### 62HDX Jockey Wheel Replacement

Machines affected carry the following serial numbers:

The Heavy Duty Jockey Wheel for the 62HDX machine (Part number 1210-80) has been shown in some cases to experience fatigue cracking leading to a failure of the shaft during operation. A updated design has been proven, eliminating the source of the fatigue cracking and using a larger diameter shaft.

**NOTE:**

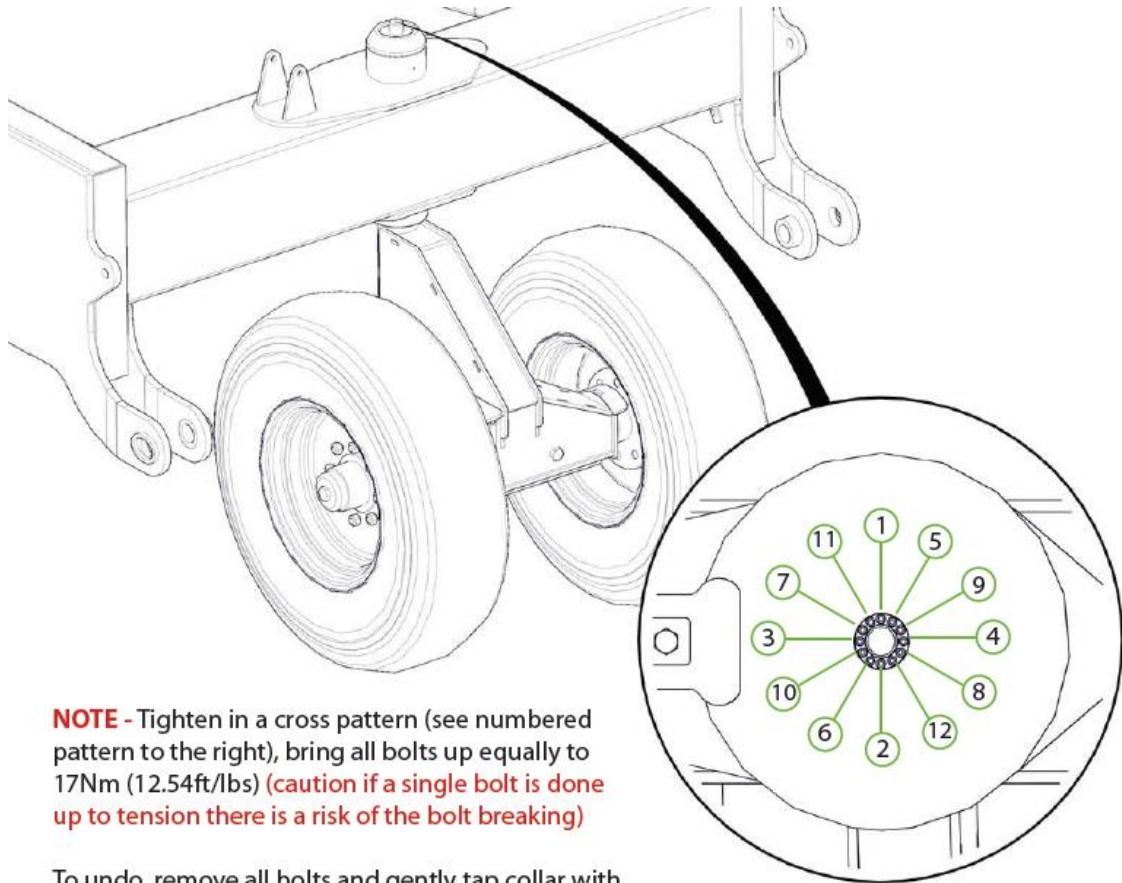
**NOTE** - Tighten in a cross pattern (see numbered pattern to the right), bring all bolts up equally to 17Nm (12.54ft/lbs) (caution if a single bolt is done up to tension there is a risk of the bolt breaking)

To undo, remove all bolts and gently tap collar with hammer. The collar will become loose.
